Figure 92-22 – FEC Decoder state diagram

Figure 92-26 – PCS Idle Insertion, input process state diagram

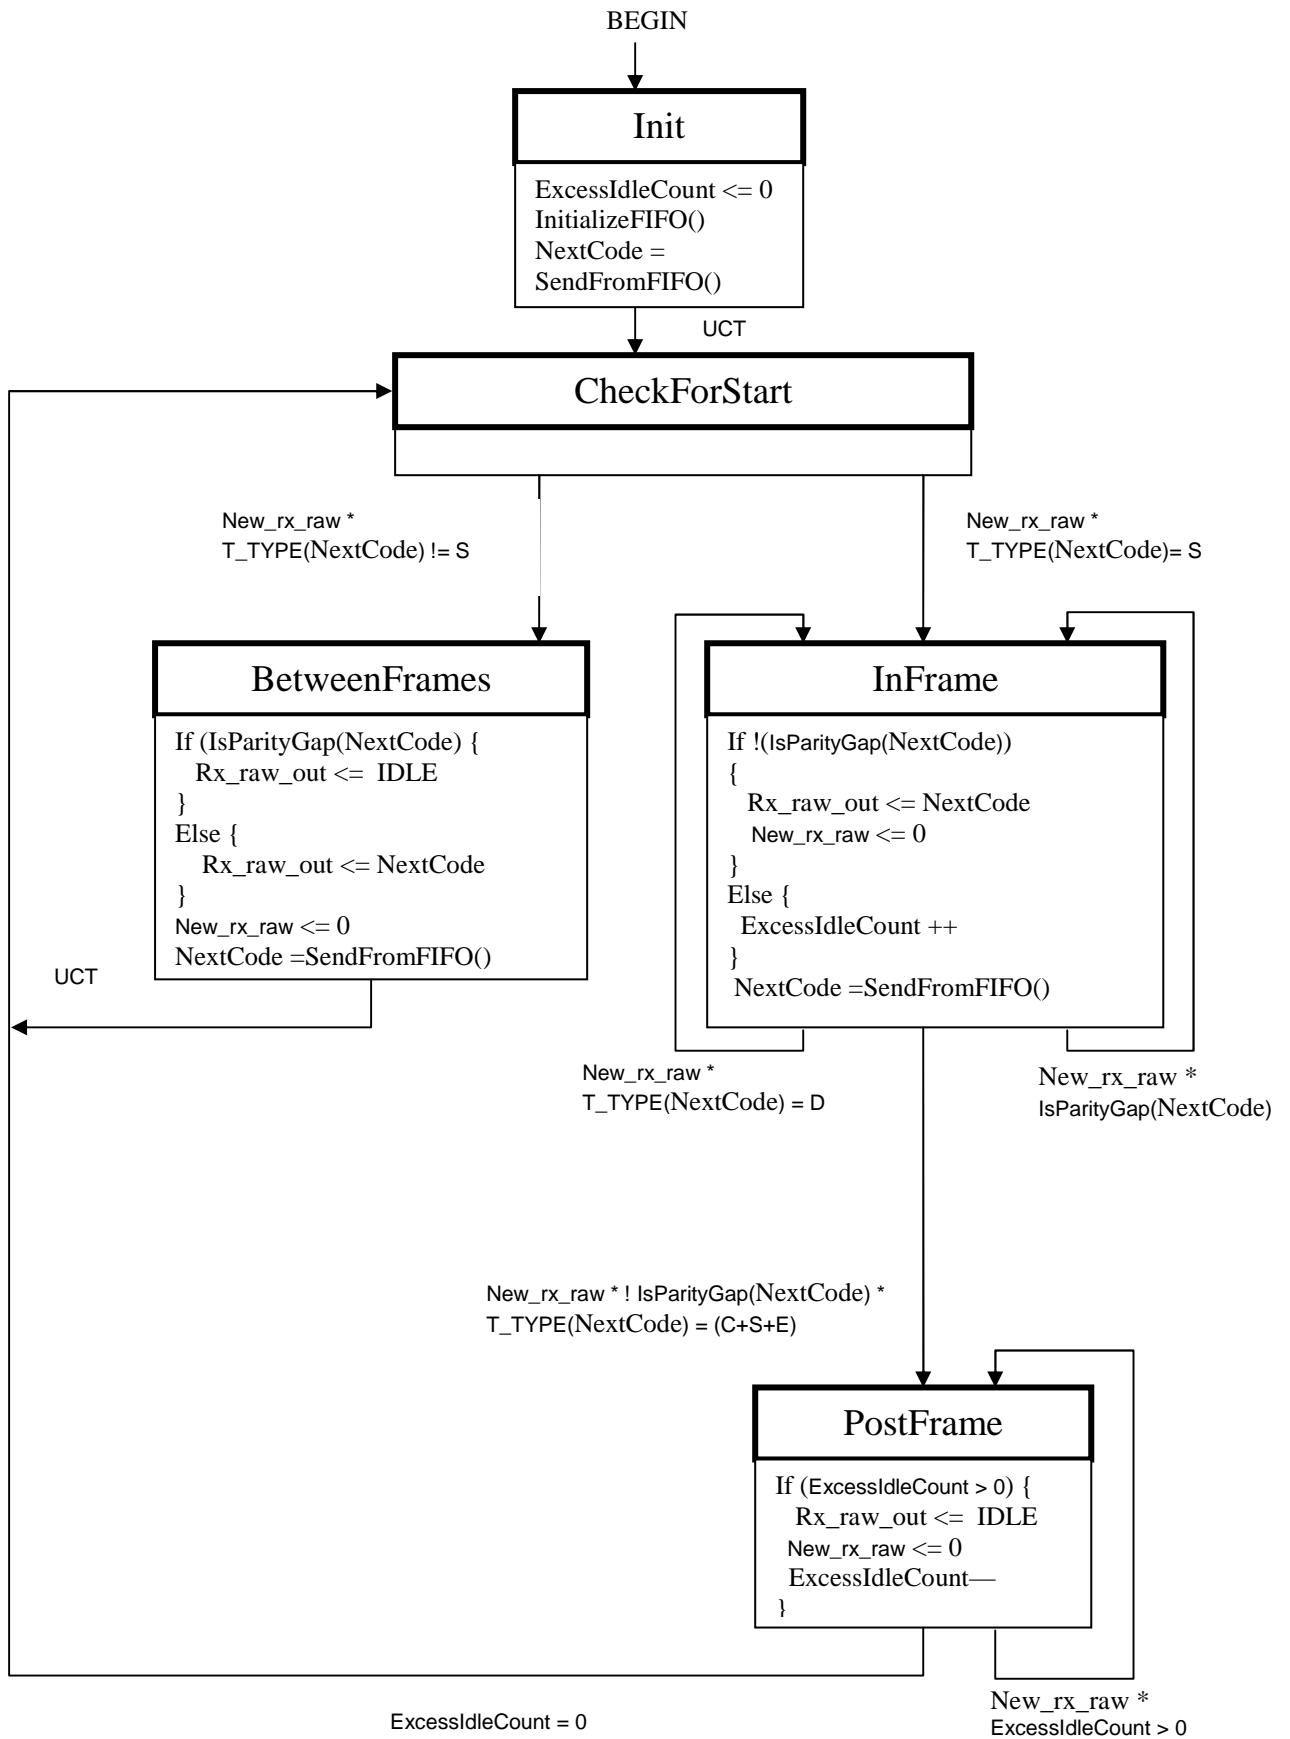
[Add new constant to 92.2.3.7.1:]

ParityGap<71:0>: A vector consisting of 72 successive '1's. This constant occupies the slots in the datastream where parity was removed by the FEC decoder. The constant's value is reserved and never otherwise appears in the datastream (cf. **46.3.2.2.**).

[Add new variable to 92.2.3.7.2:]

new_rx_raw: becomes TRUE whenever a new value of rx_raw_out is required (ie. to write over the XGMII) and is FALSE otherwise. The Idle insertion process sets **new_rx_raw** to FALSE after it has written a new value to rx_raw_out.

[Add new function to 92.2.3.7.3:]

IsParityGap(rx_vector<71:0>): returns TRUE if rx_vector is the ParityGap constant and FALSE otherwise.

[modify the sentence on 125 line 37 to say the following:]

This FIFO is internal to the Idle Insertion function and is shared by input and output processes of Idle Insertion. Upon initialization, all elements of this array are set to contain 72-bit vectors representing /I/ characters. FIFO_II is a zero-based array of size sufficient to hold all the parity data associated with a maximum size frame.
